Project: Fire Station 31 - Project No. MB-1478 Replace Fire Station 31

Fire Station #31 - COR#007

Fire Station #31 - COR# 009 ASI-006

ARCHITECT'S SUPPLEMENTAL INSTRUCTION No. 009

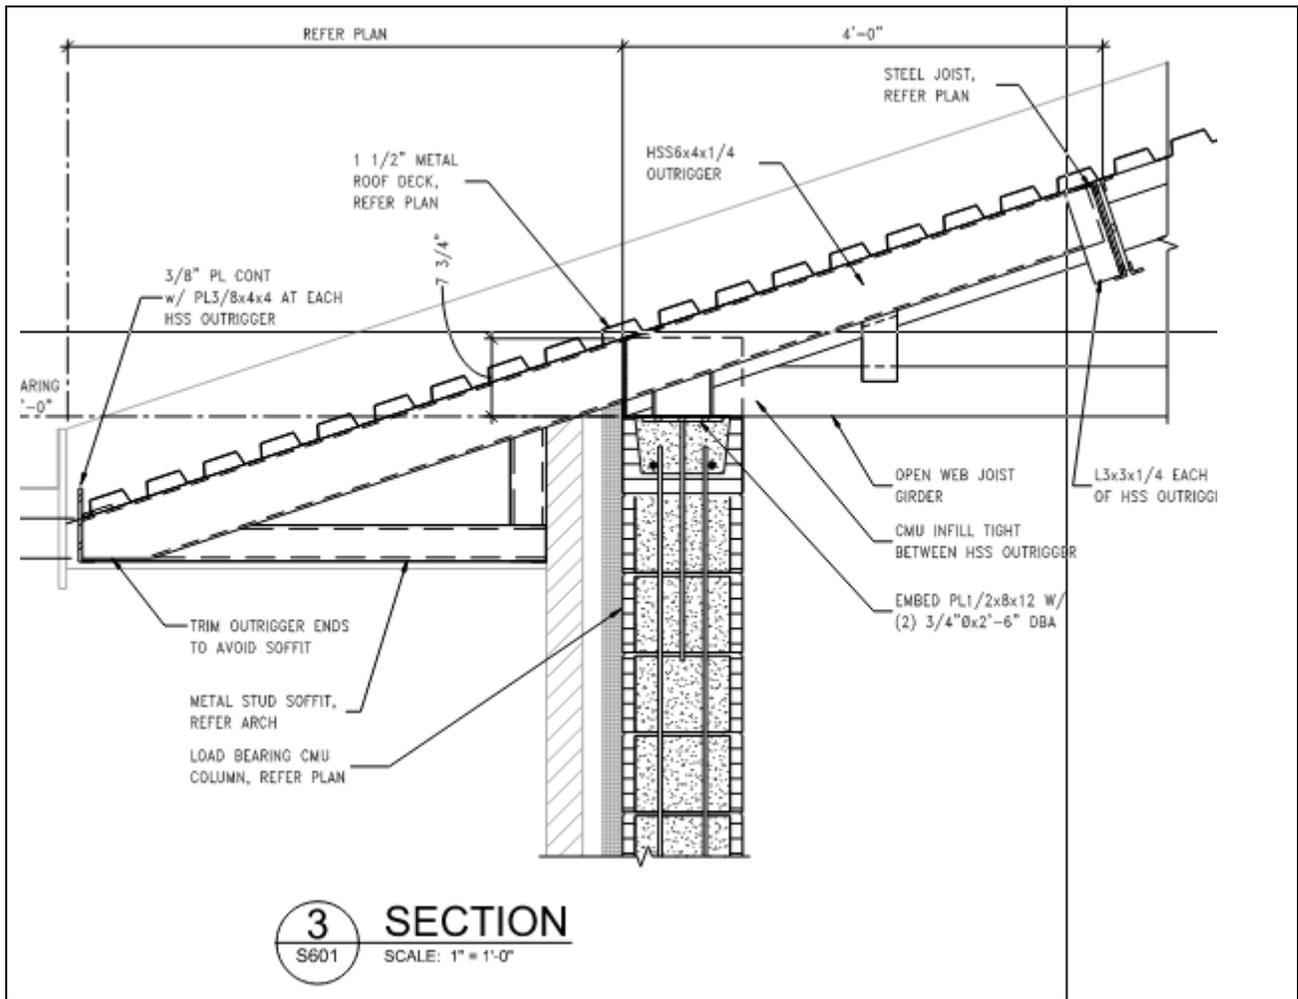
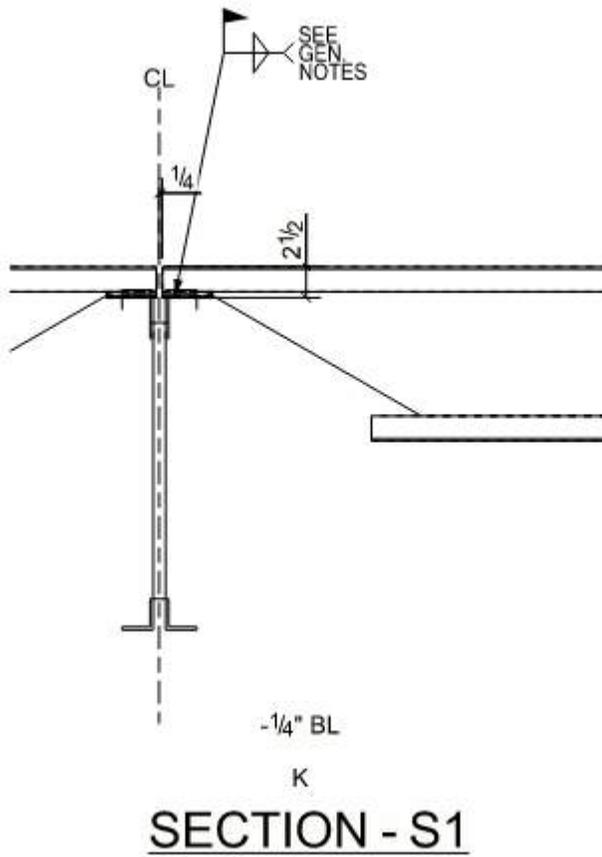
On detail 3/S601 it shows the joist to be flush, but that's not possible. The joist sits on top of the girder 2 1/2" above. We need a solution to support the deck

Detail 3/S601 shows the joist sitting on the girder. However that leaves a gap at the joist girder outrigger. KFC takes no exceptions to the proposed solution of adding a HSS 2 1/2x2 1/2x 3/16 tube on top of the joist girders between the ends and the first joist. Attach with a 2" long flare bevel weld every 1'-0", alternating sides.

Sheet A214 is reissued to clarify the tile layout in the MENS RM 126

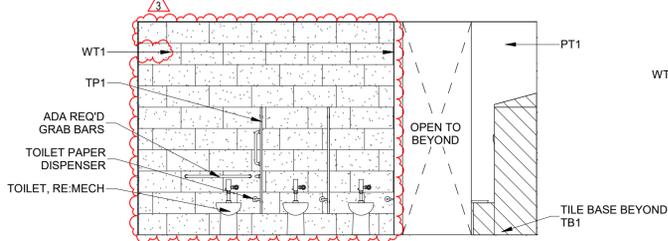
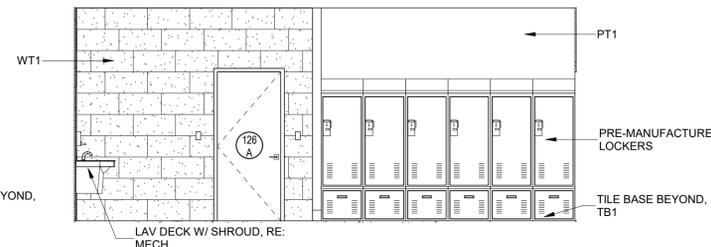
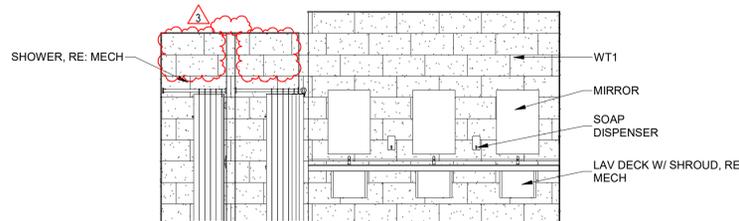
CHANGE ORDER FOR THE UPDATED ASI NO. 008 CLARIFICATION FOR THE MENS RESTROOM 126 TILE LAYOUT.

ELECTRICAL SYSTEMS PLAN - ALTERNATE #2

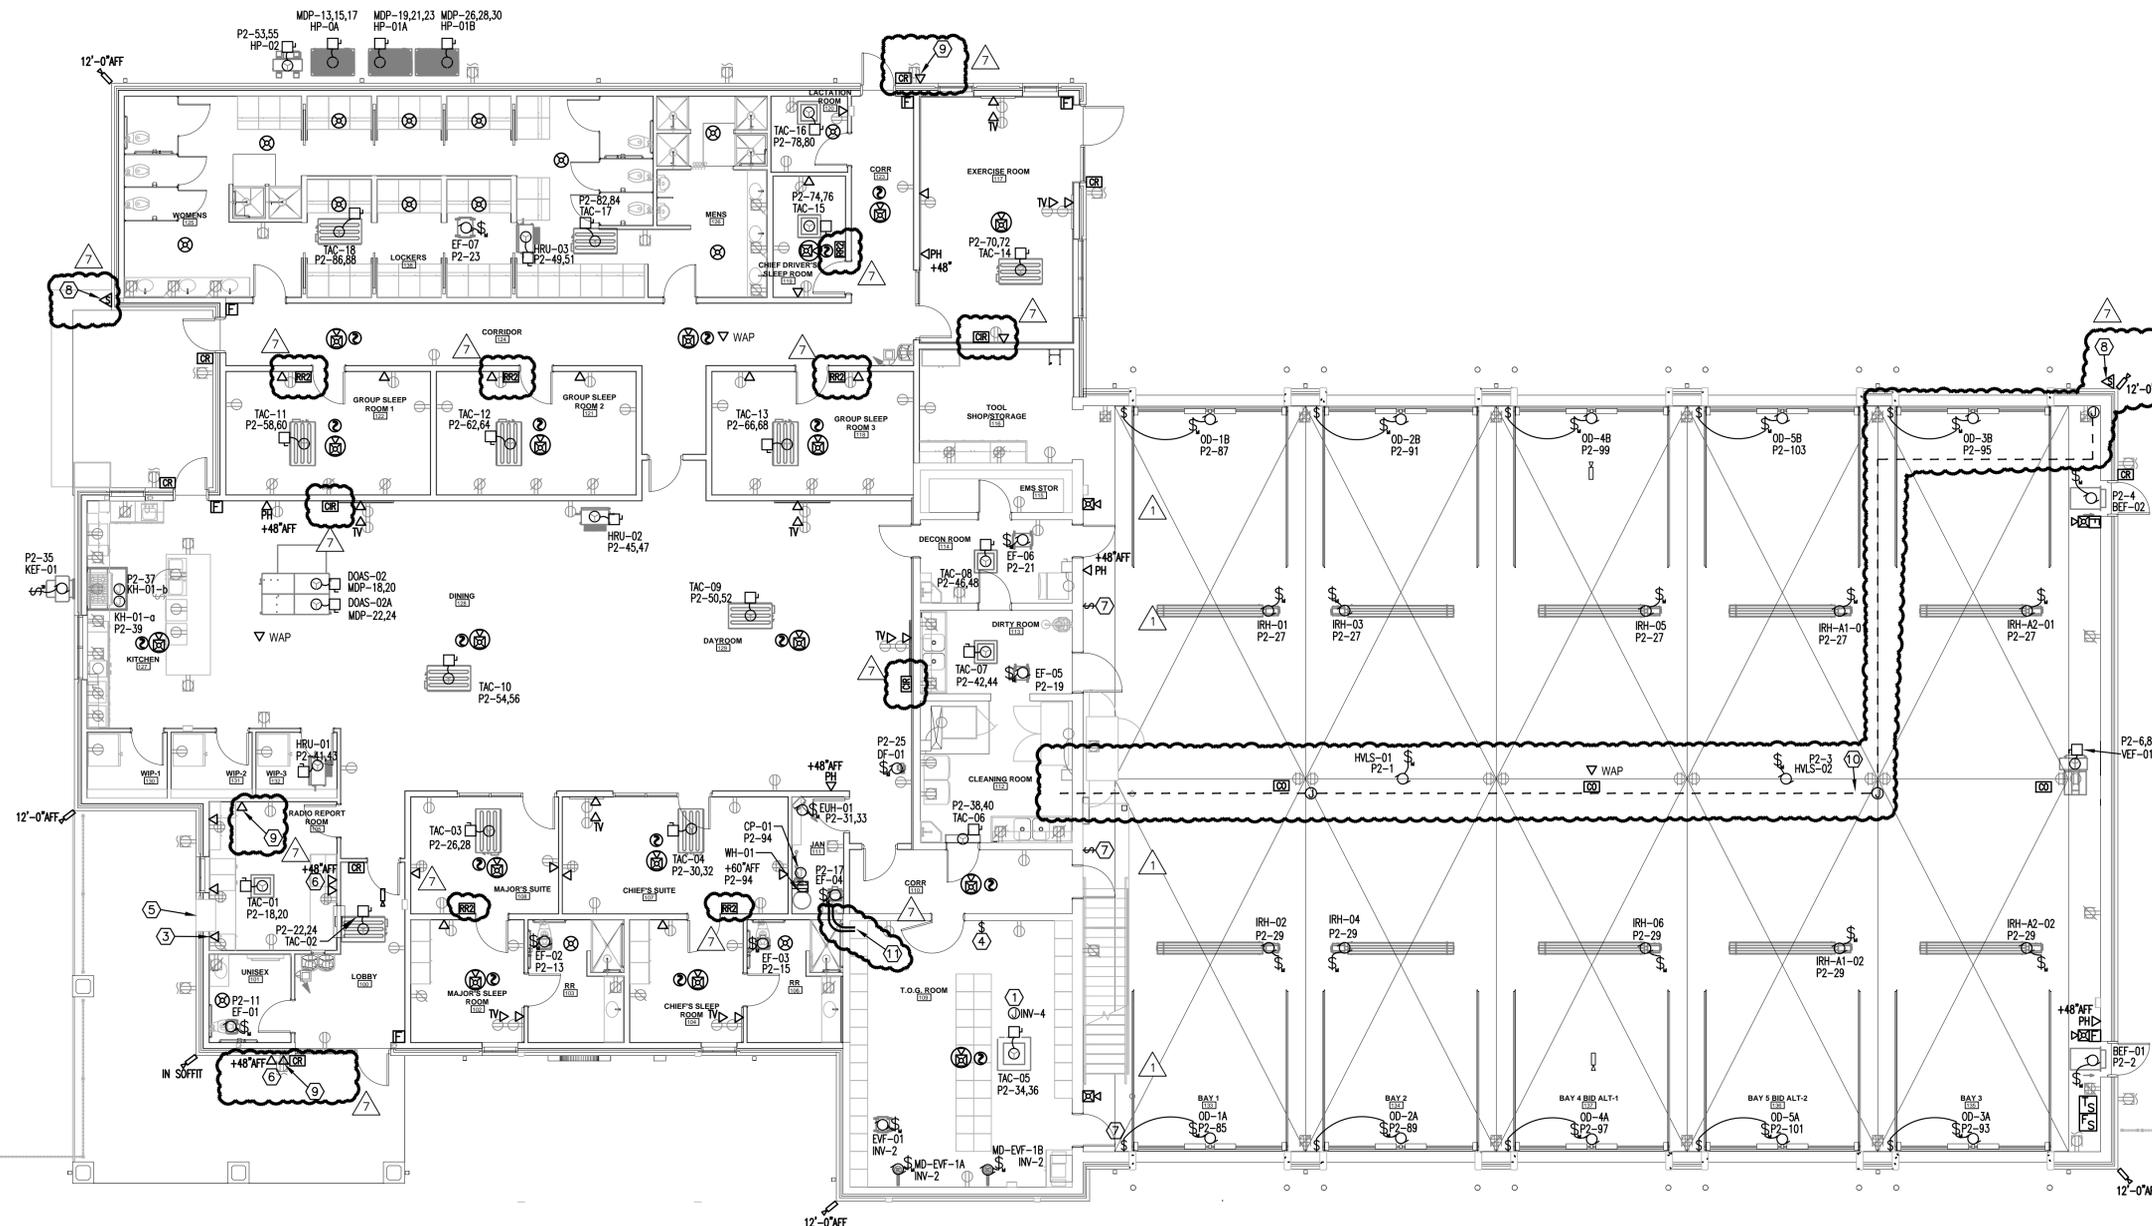
Sheet E420 is revised and reissued to add the owner requested rough-in for the Fire Departments Alerting system.

- I. DEVICES LABELED 'RR2' ARE APPROXIMATE ROUGH-IN LOCATIONS FOR THE ROOM REMOTES (PROVIDED BY OTHER) FOR THE ALERTING SYSTEM. THEY ARE INTENDED TO BE INSTALLED 58" FROM THE FLOOR TO THE BOTTOM OF THE CONDUIT BOX AND 6"-12" FROM THE LIGHT SWITCH INSIDE ROOMS 118, 119, 121, AND 122. IN ROOMS 107 AND 108 THEY ARE INTENDED TO BE INSTALLED 12" FROM THE NEAREST DOOR FRAME TO THE APPROXIMATE LOCATION SHOWN ON PLANS. PROVIDE 4-GANG ROUGH-IN BOX WITH DIMENSIONS AT LEAST 2-3/4" HIGH BY 7-3/8" WIDE WITH A 1-1/4" CONDUIT EXTENDED ABOVE THE CEILING IN AN ACCESSIBLE LOCATION.
- J. DEVICES LABELED 'CIR' ARE APPROXIMATE ROUGH-IN LOCATIONS FOR COLOR INDICATOR REMOTES (PROVIDED BY OTHERS) FOR THE ALERTING SYSTEM. PROVIDE SINGLE GANG BOX MOUNTED HORIZONTALLY AT 100" AFF WITH A 1" CONDUIT EXTENDED ABOVE THE CEILING IN AN ACCESSIBLE LOCATION.

43 SITE PLAN
SCALE: 1" = 20'-0"
REFER: NORTH

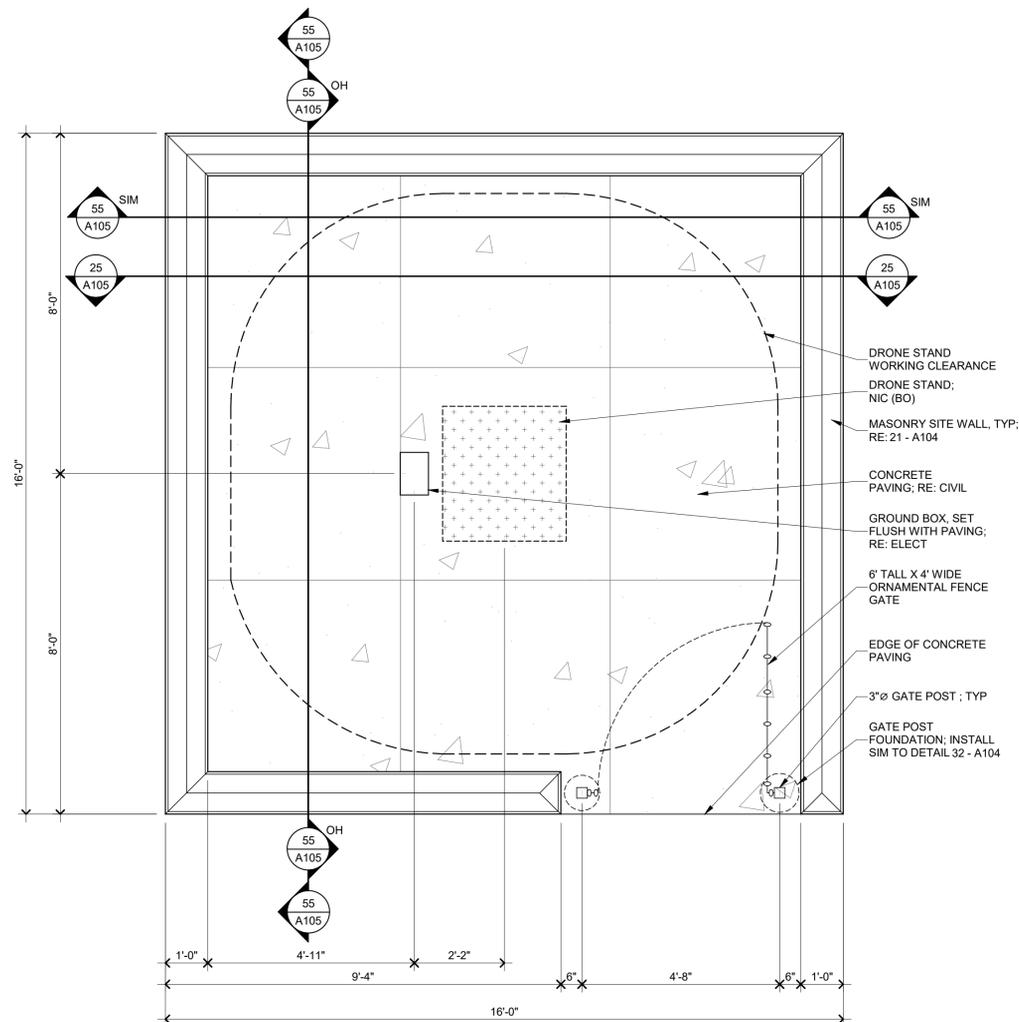
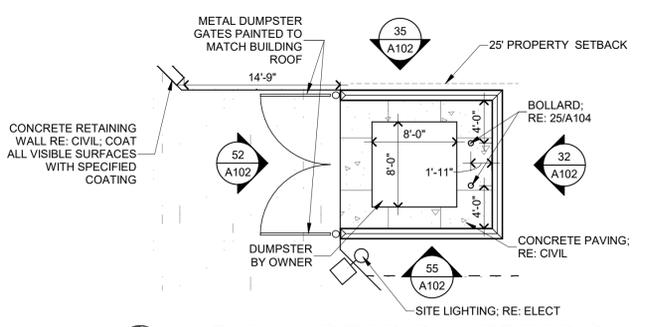
The Fire Department is planning on installing a drone and dock / stand to the station's site. Attached are sheets C301, C501, A101, A105, E100, E420, E430, and E510 showing the rough-in and enclosure requirements for the future drone dock. The drone and dock will be installed by the owner.

S ELECTRICAL SITE PLAN

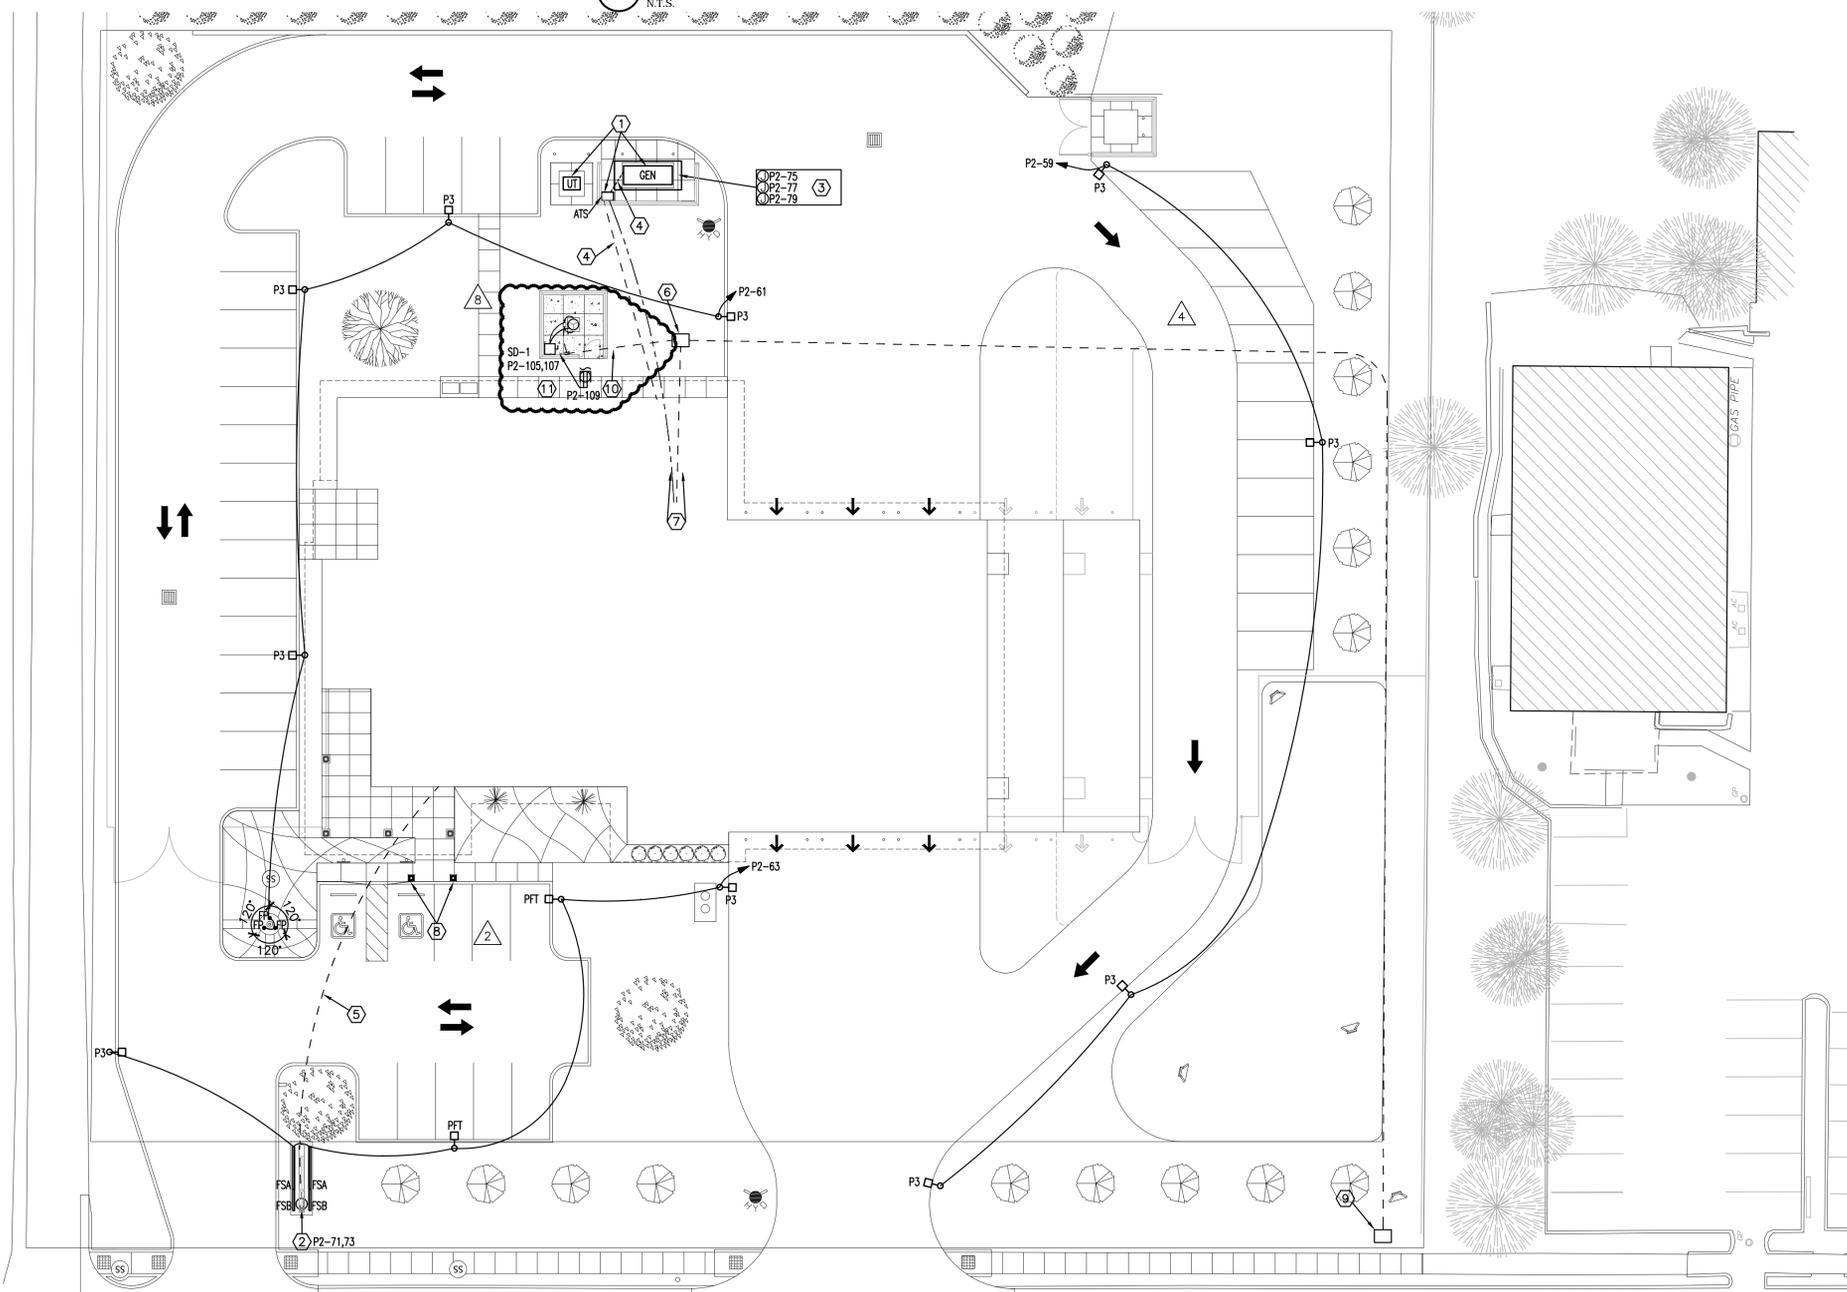
- UTILIZE SITE LIGHTING RACEWAY FOR ADDITIONAL BRANCH CIRCUITING NEEDED FOR DRONE POWER AND RECEPTACLE.
